**ADDENDUM
(AD)**

PROJECT: Nebraska Department of Transportation
District 1 Maintenance Facility
Seward, Nebraska

AD NO.: AD-2

DATE: December 10, 2024

SHEET NUMBER
A-101

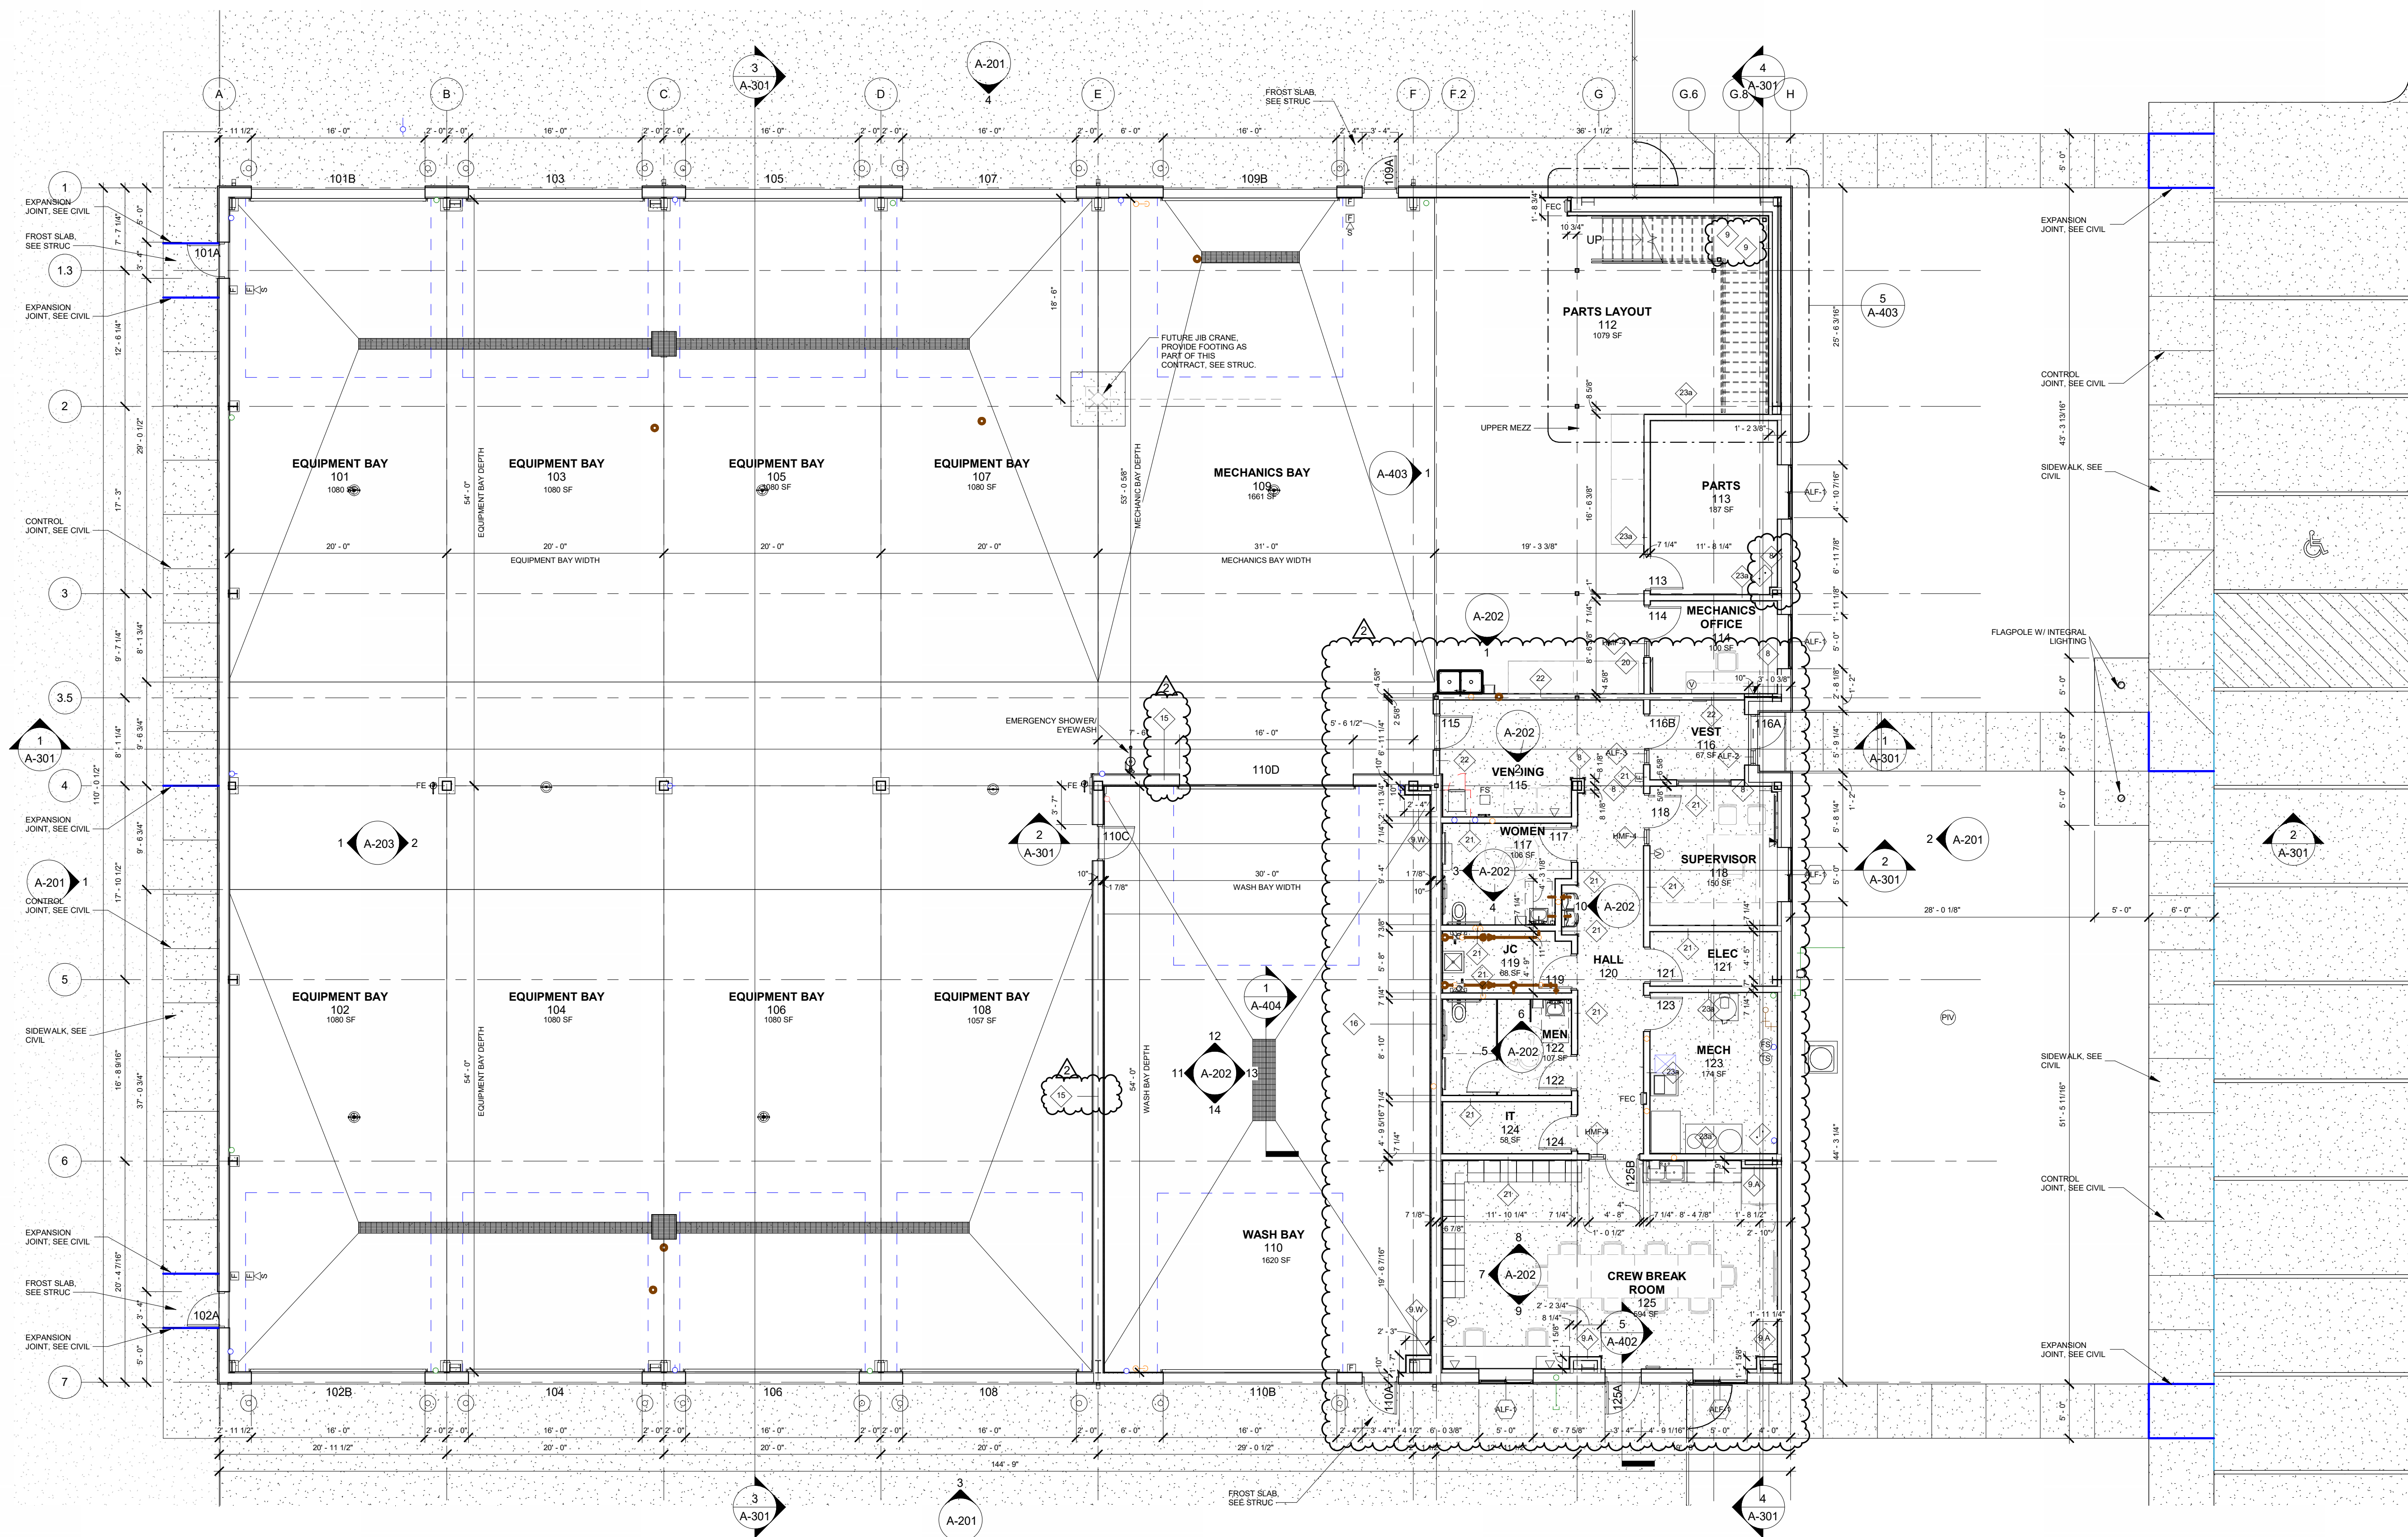
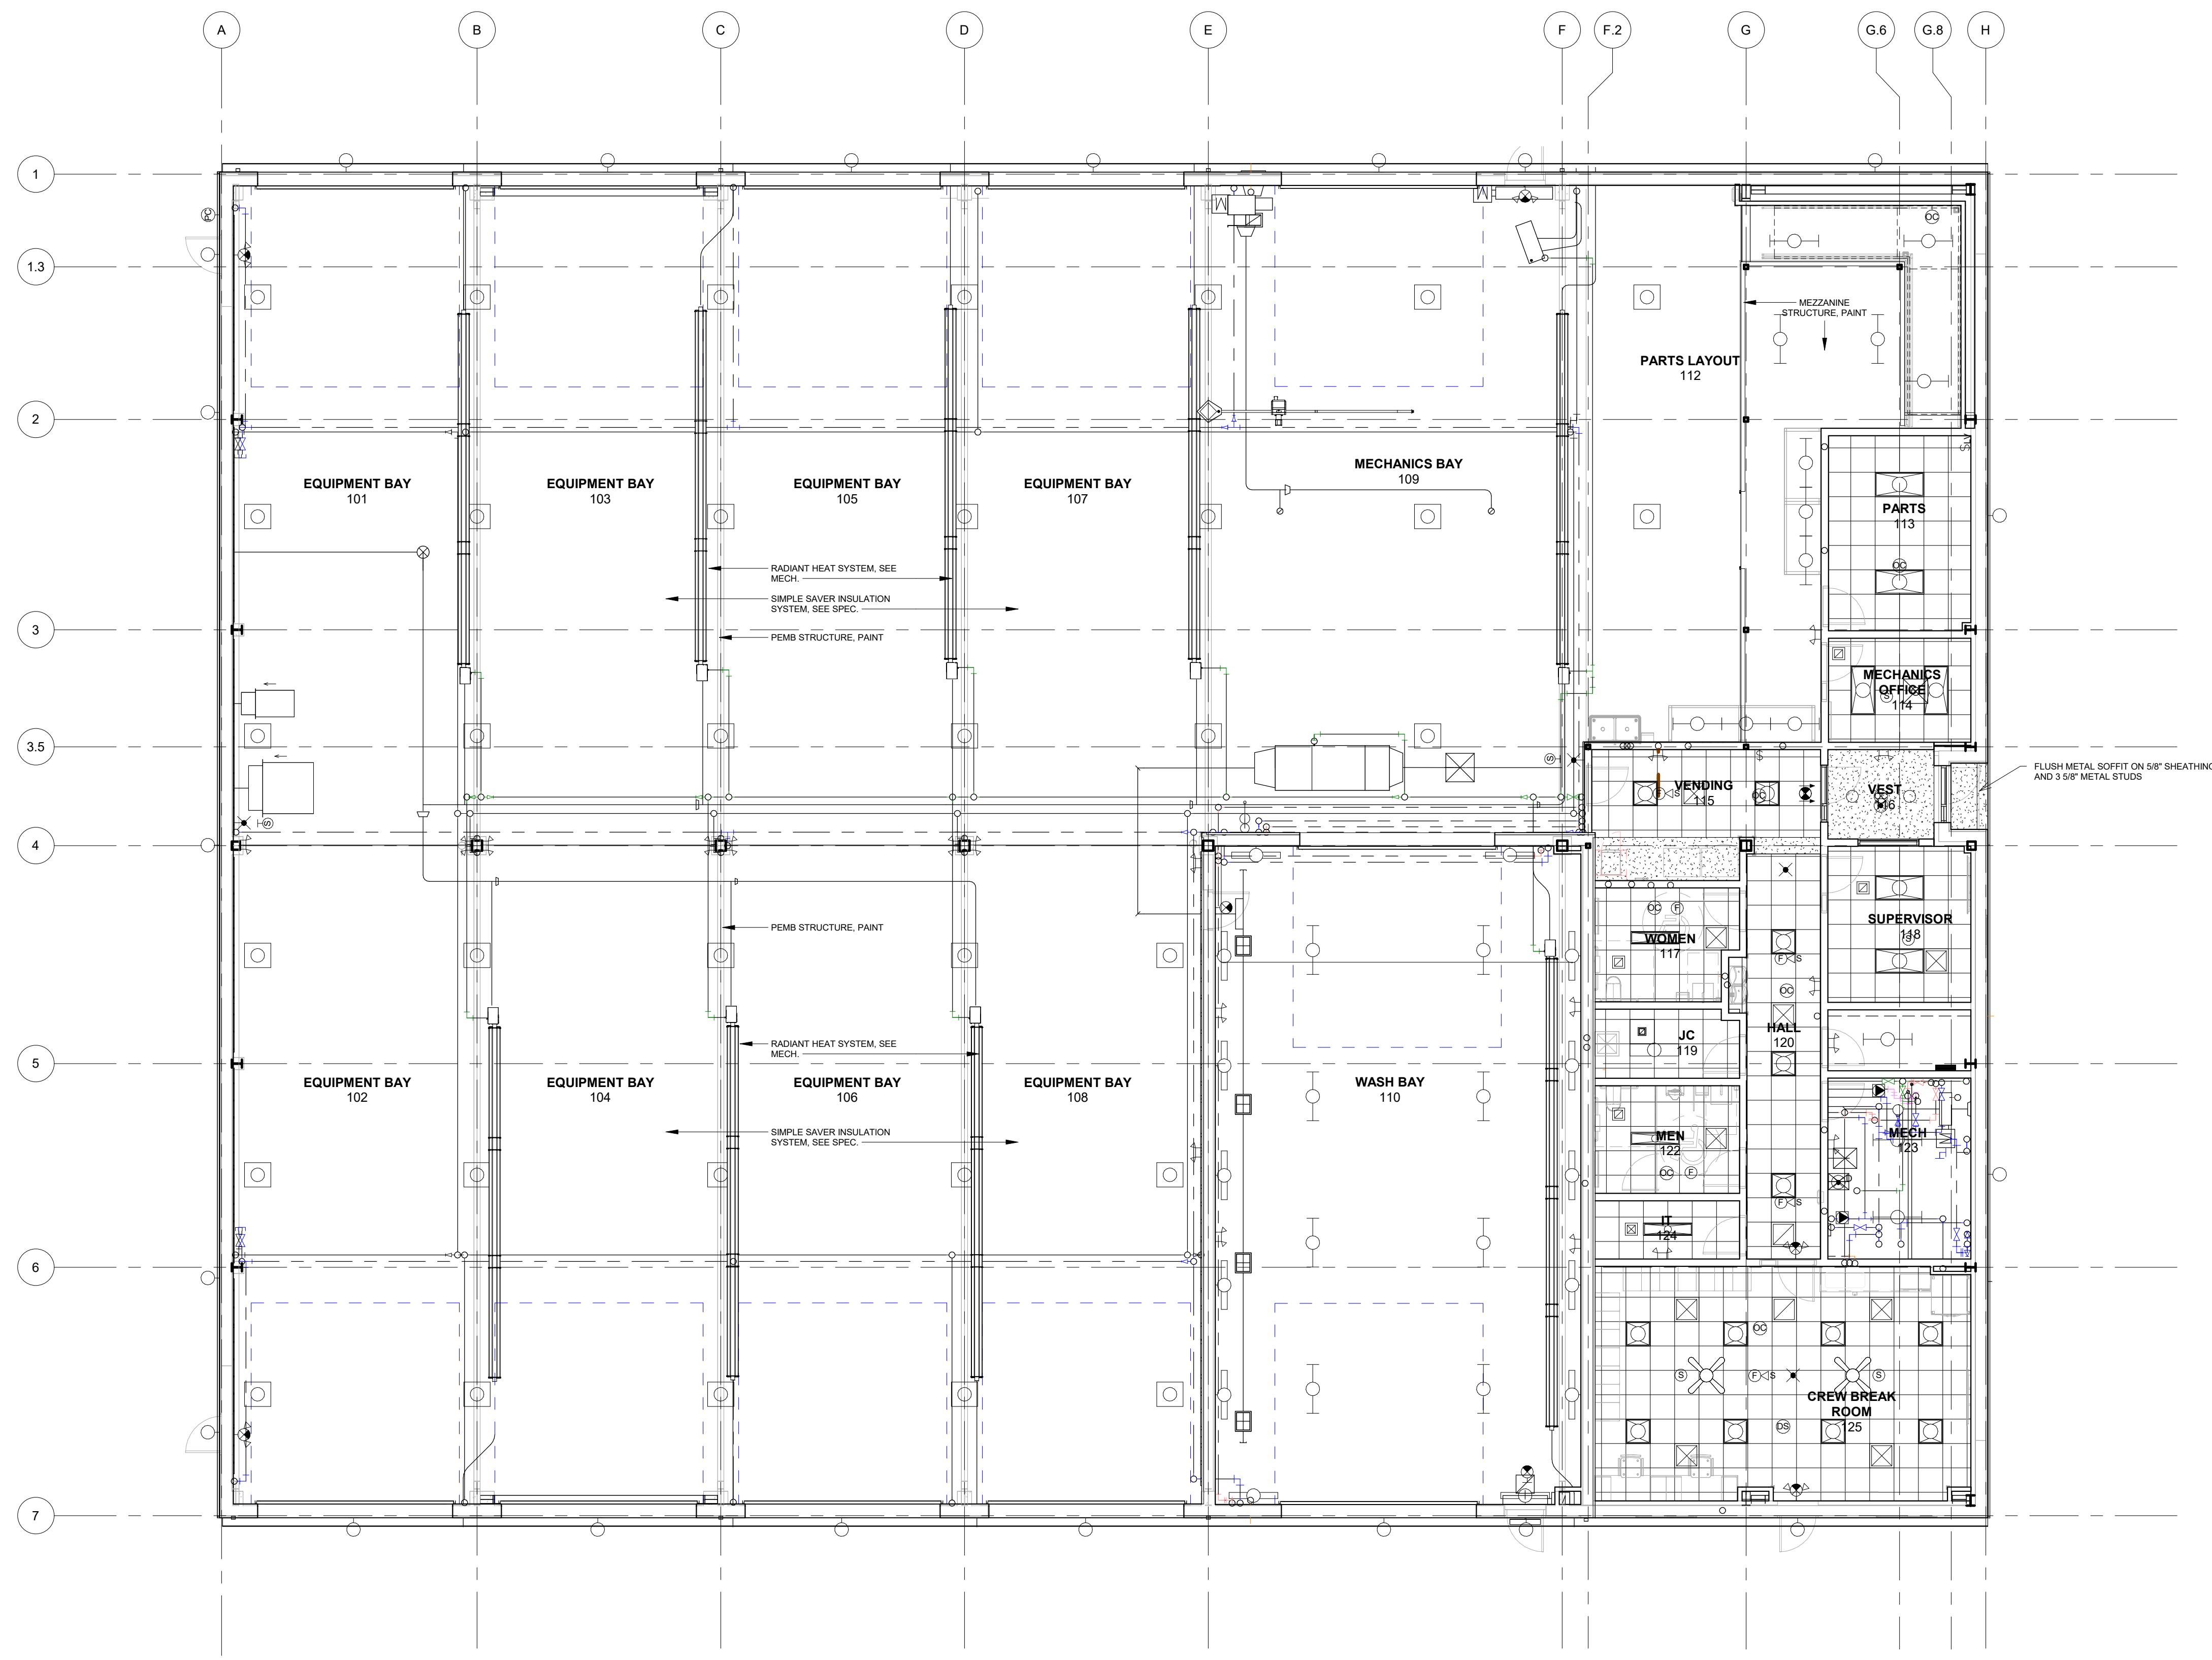
In reference to Sheet A-101 – FIRST LEVEL FLOOR PLAN, see attached revised Sheet A-101. Missing wall partition tags have been tagged.

SHEET NUMBER
A-102

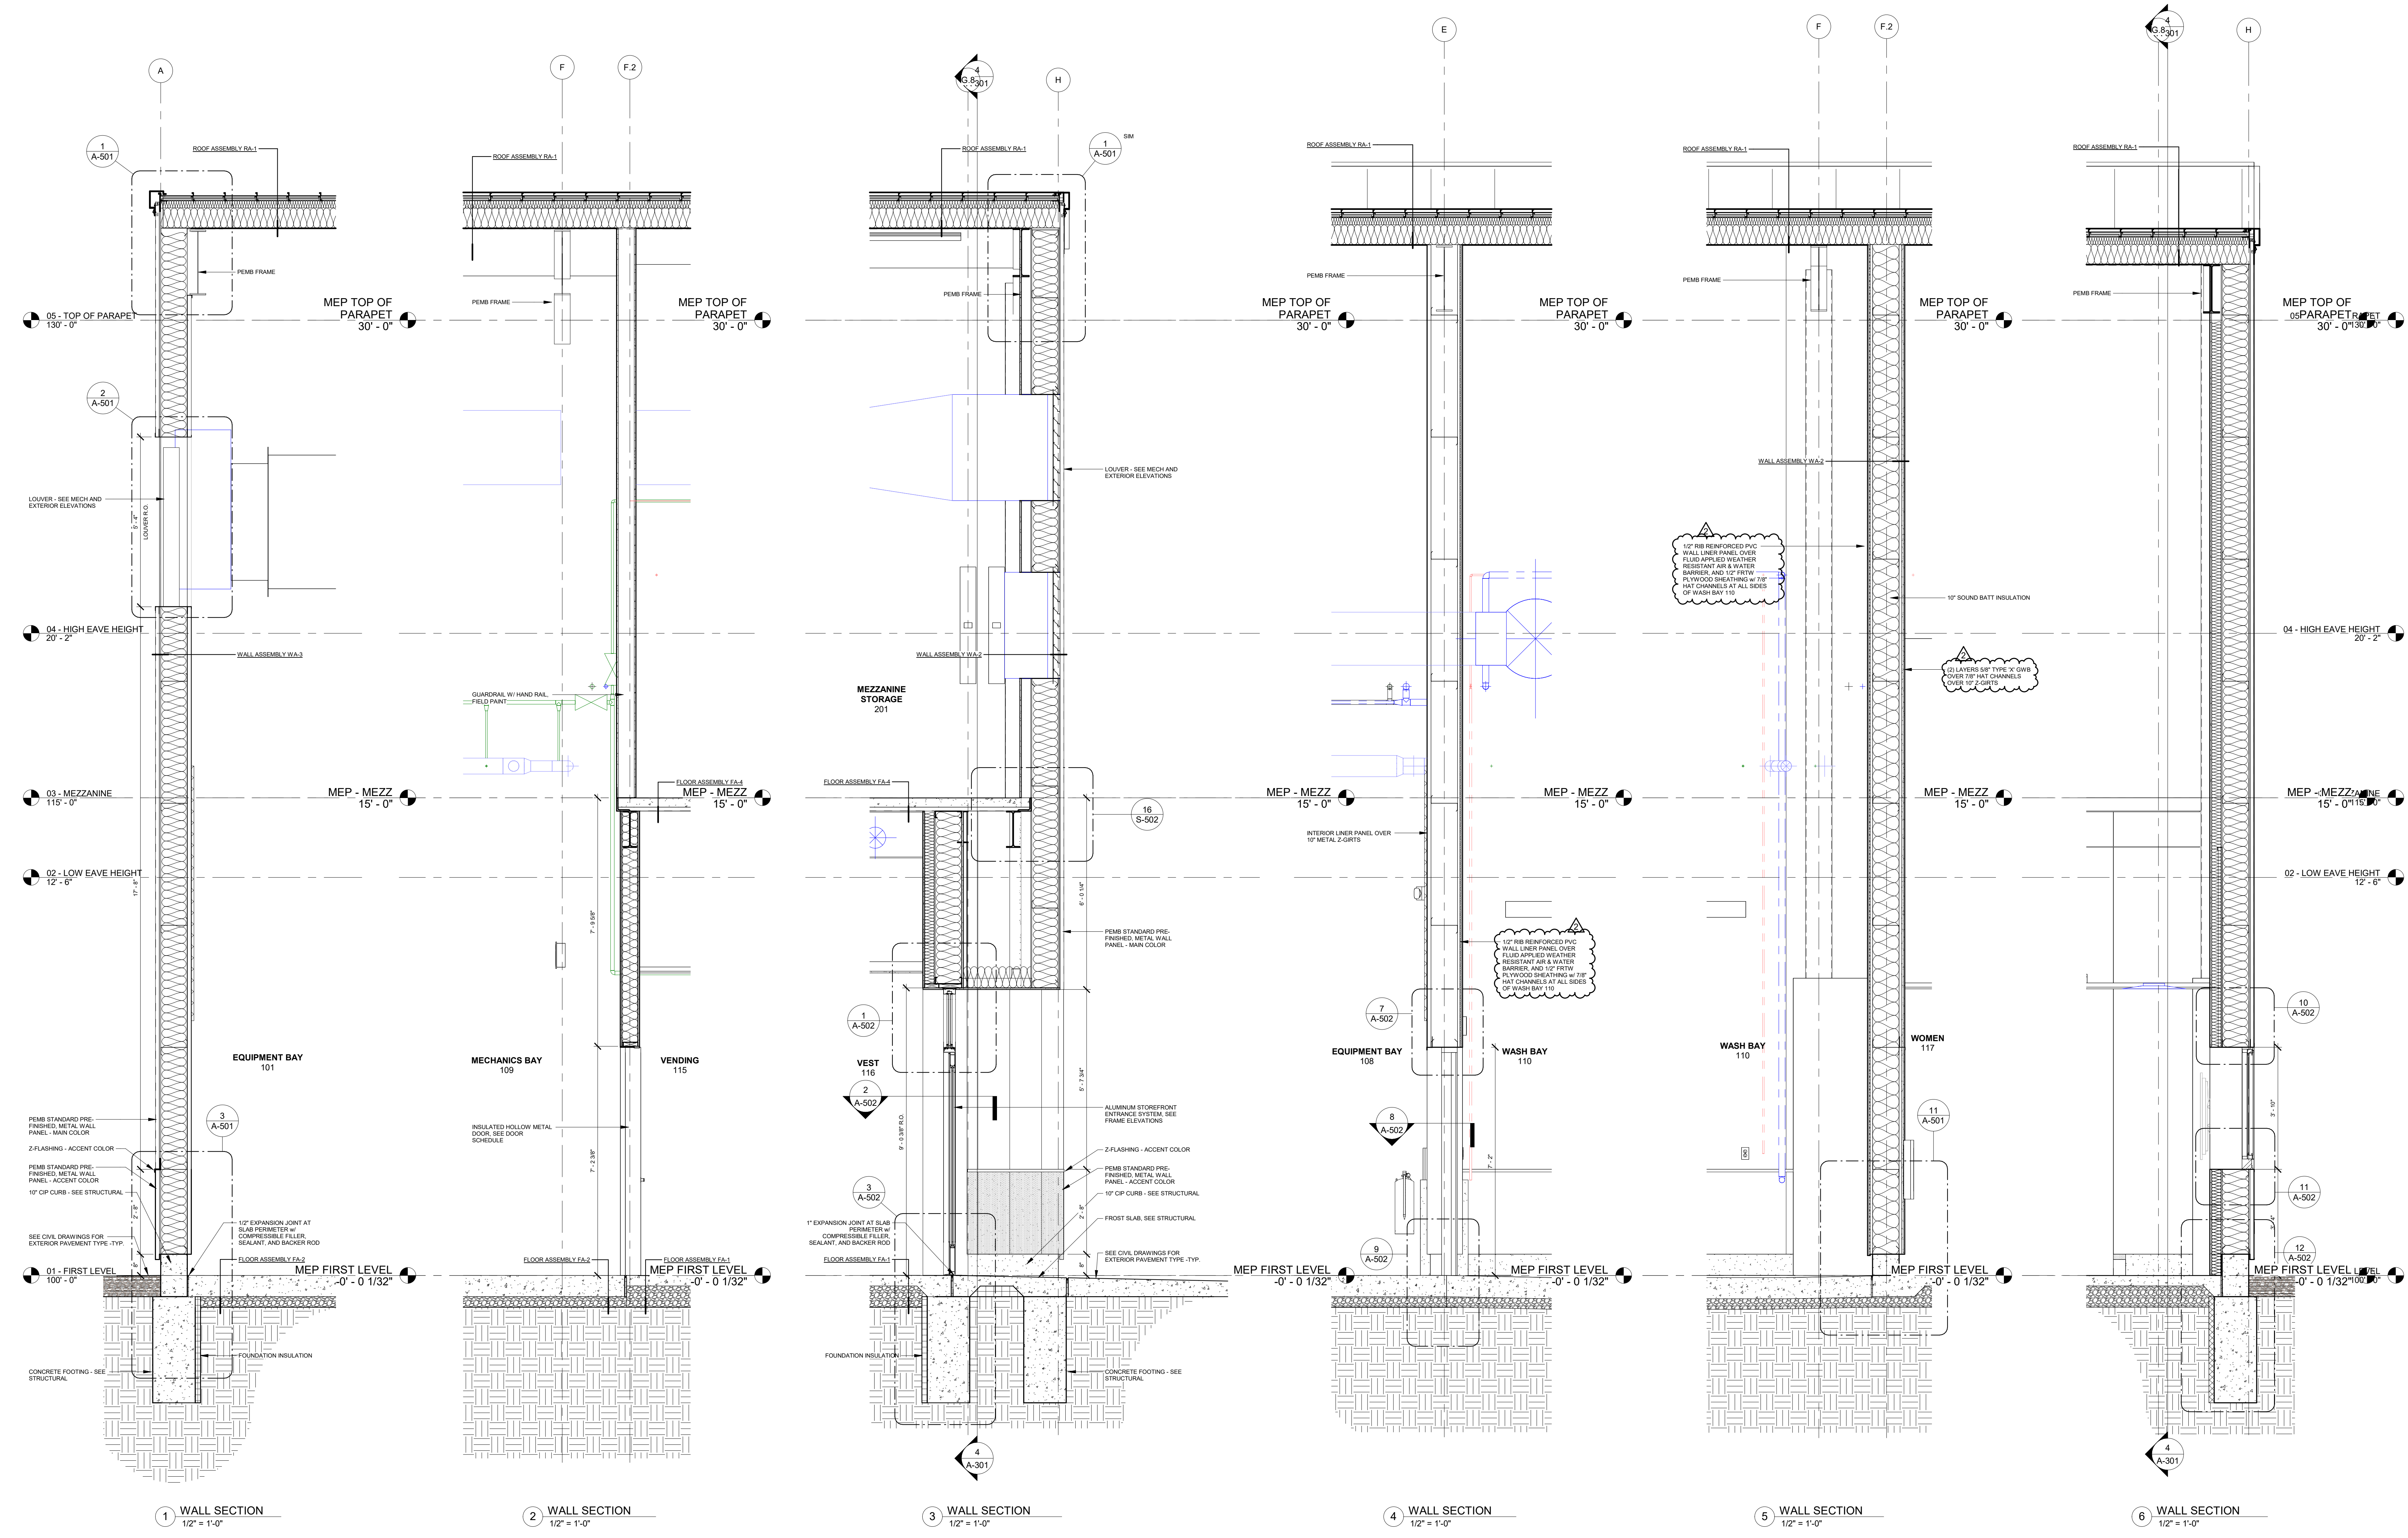
In reference to Sheet A-102 – FIRST LEVEL CEILING PLAN, see attached revised Sheet A-102. The previous equipment bay hatch pattern has been removed to eliminate confusion with the office grid ceiling. The reflected ceiling lights and diffusers have been adjusted to line up with the ceiling grid in the office portion of the building.

THE PREVIOUS EQUIPMENT BAY HATCH HAS BEEN REMOVED AND LIGHTS AND DIFFUSERS HAVE BEEN ADJUSTED IN THE OFFICE PORTION OF THE BUILDING.
